**CORRECTION TO "TALON ZEPHYR" R/C Pylon IN NEW A.M. ANNUAL (Pg. 23)**

### LANDING GEAR DETAILS

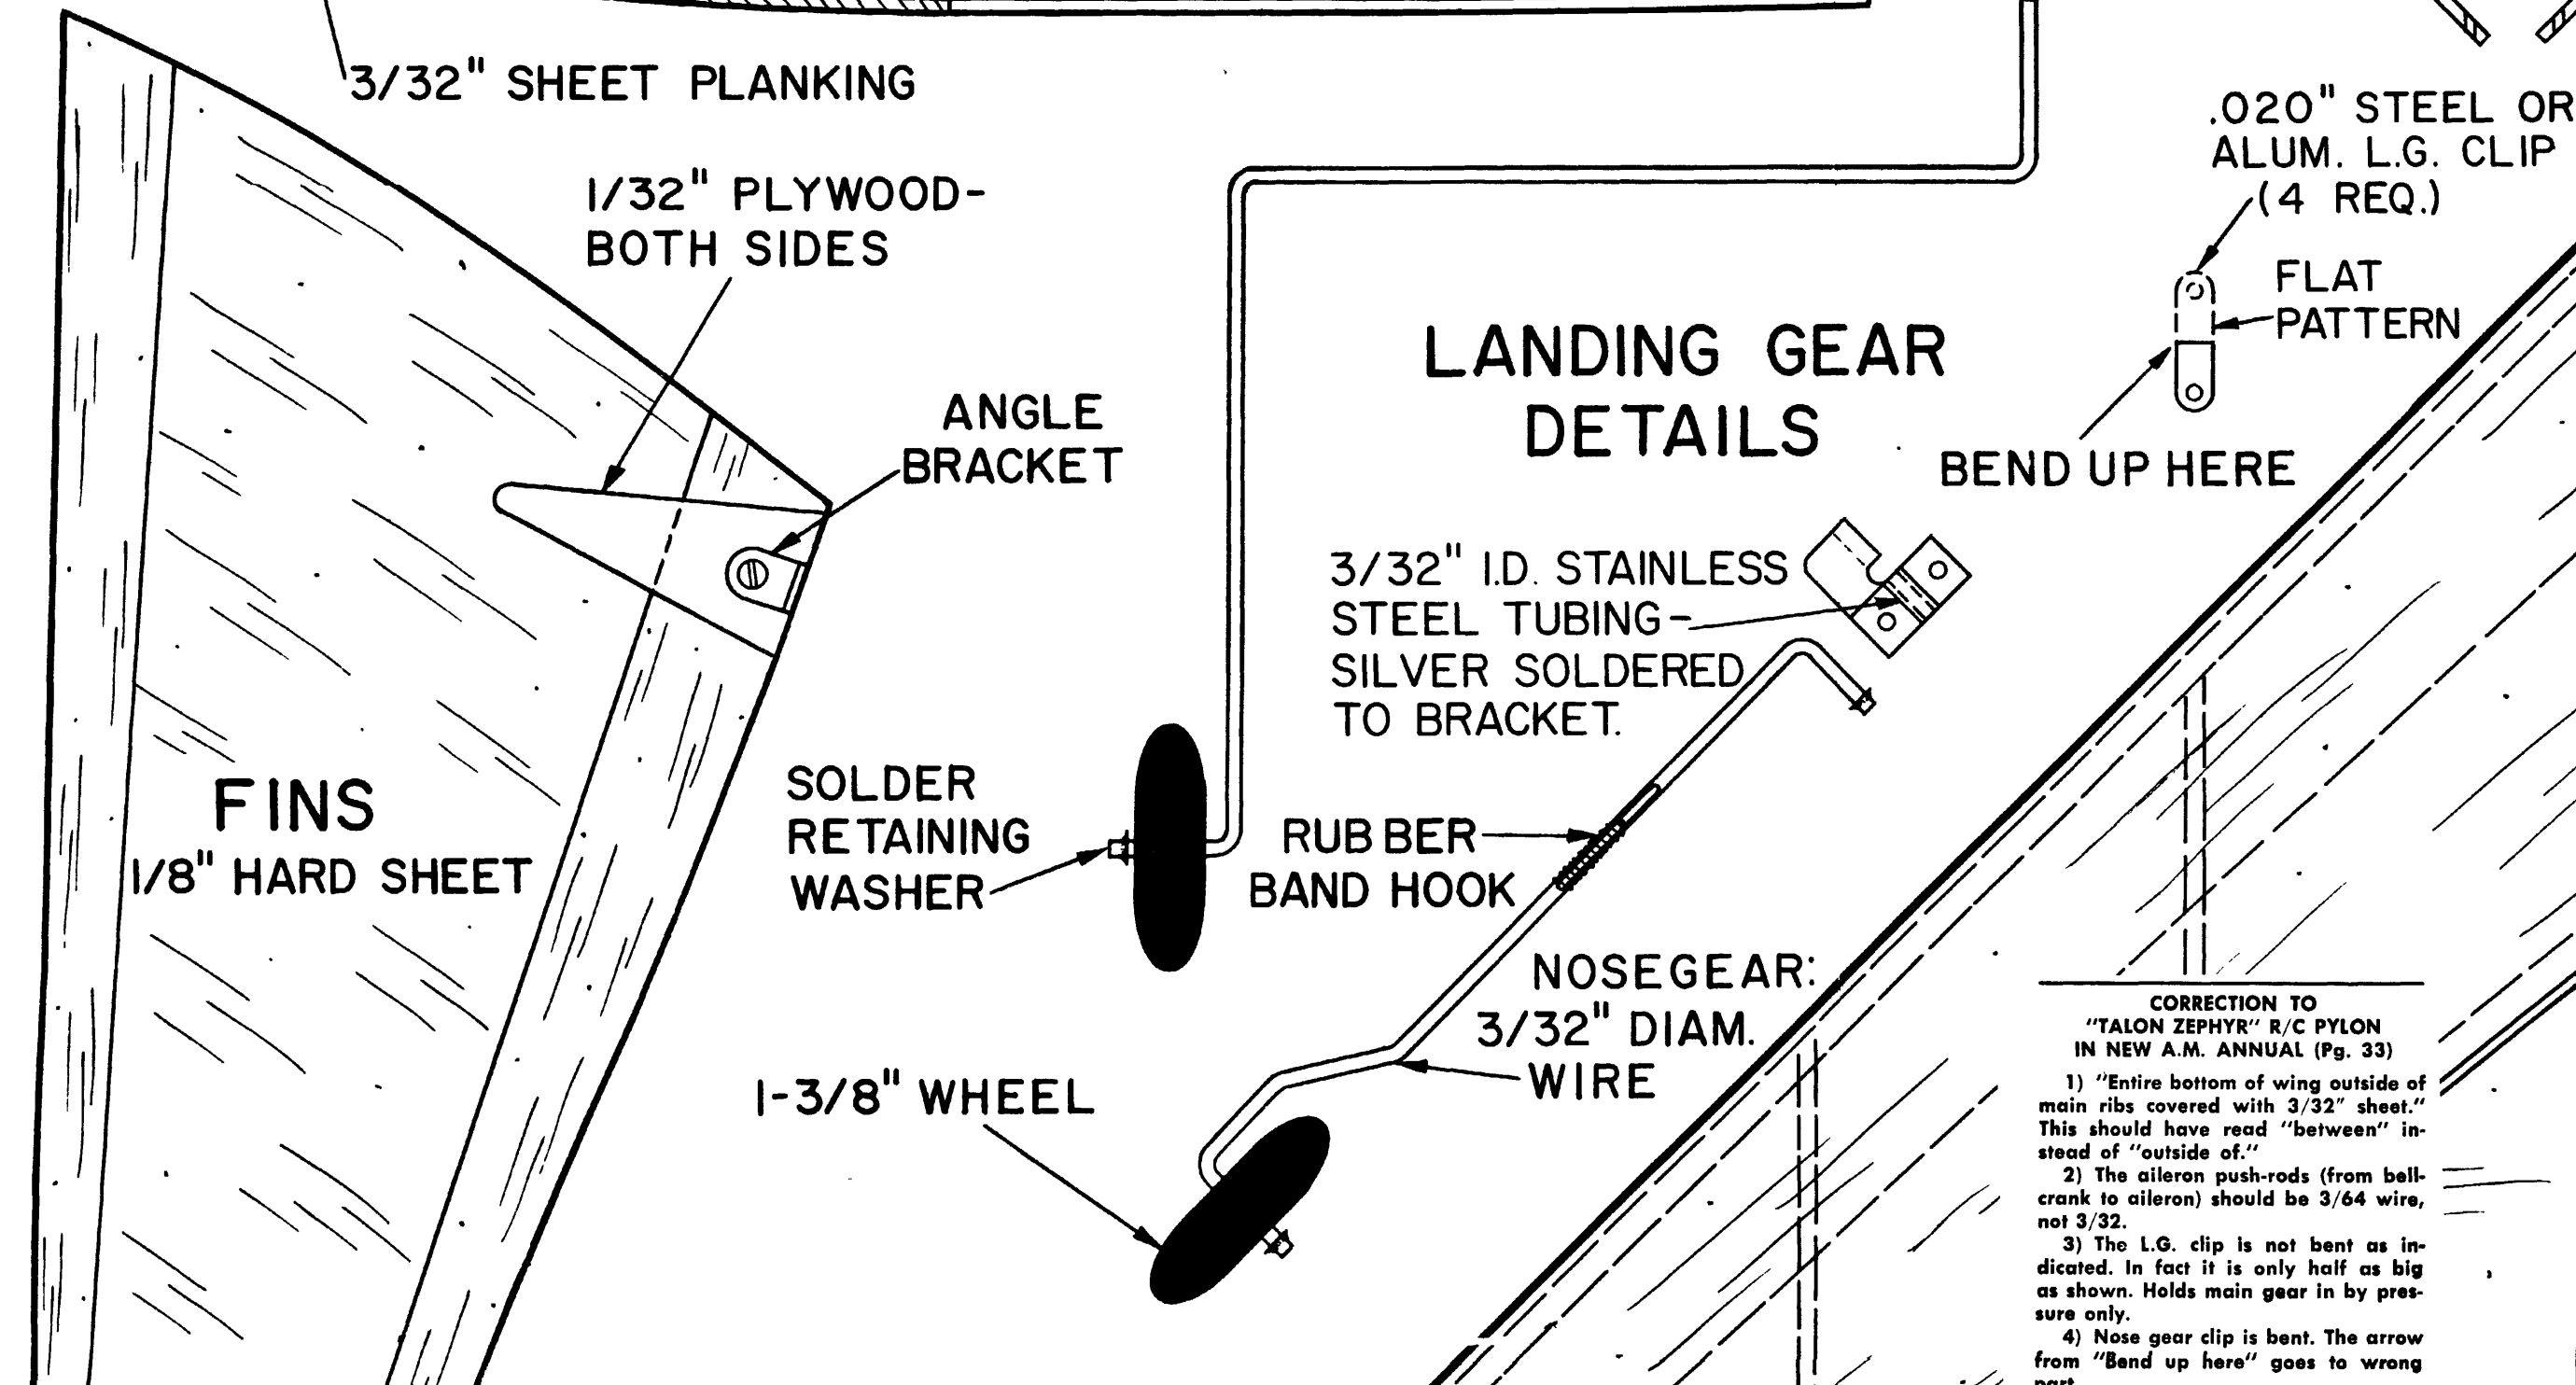
- 1) "Entire bottom of wing outside of main ribs covered with 3/32\" sheet." This should have read "between" instead of "outside of."
- 2) The aileron push-rod (from ball crank to aileron) should be 3/64 wire, not 3/32.
- 3) The L.G. clip is not bent as indicated. In fact it is only half as big as shown. Holds main gear in by pressure only.
- 4) Nose gear clip is bent. The arrow from "Bend up here" goes to wrong part.

### PLAN LAYOUT

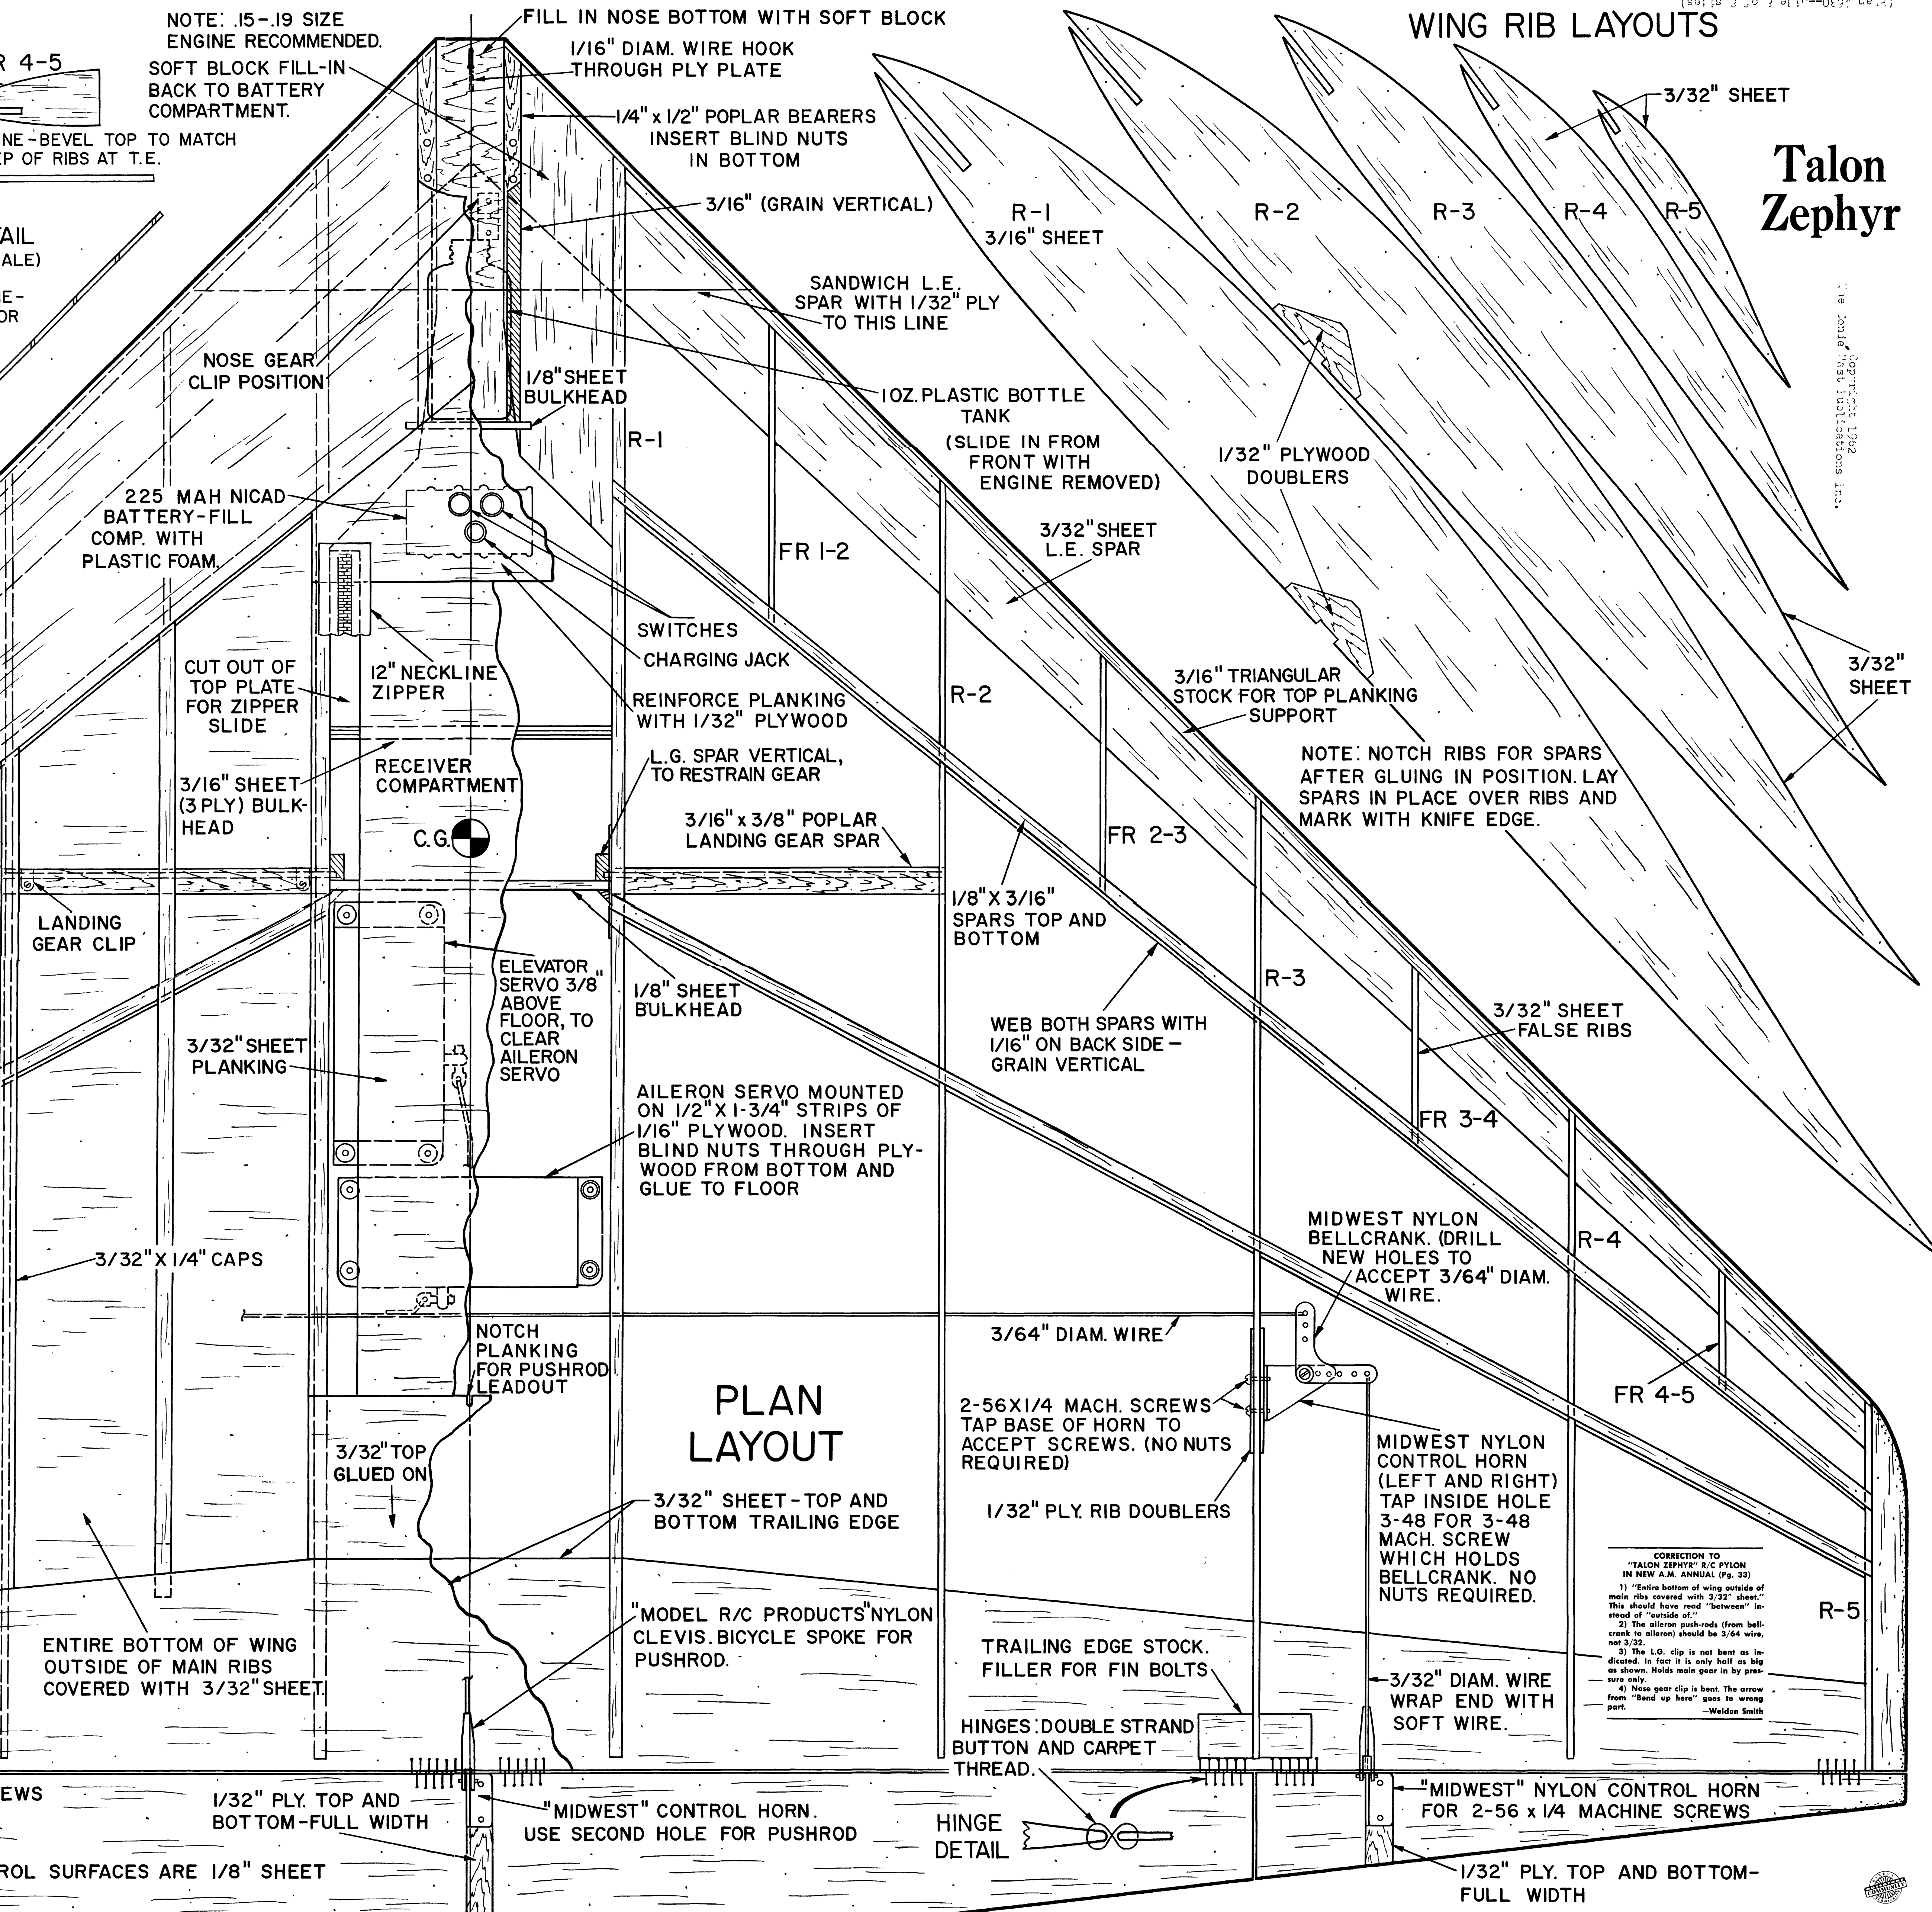
- 1) "Entire bottom of wing outside of main ribs covered with 3/32\" sheet." This should have read "between" instead of "outside of."
- 2) The aileron push-rod (from ball crank to aileron) should be 3/64 wire, not 3/32.
- 3) The L.G. clip is not bent as indicated. In fact it is only half as big as shown. Holds main gear in by pressure only.
- 4) Nose gear clip is bent. The arrow from "Bend up here" goes to wrong part.
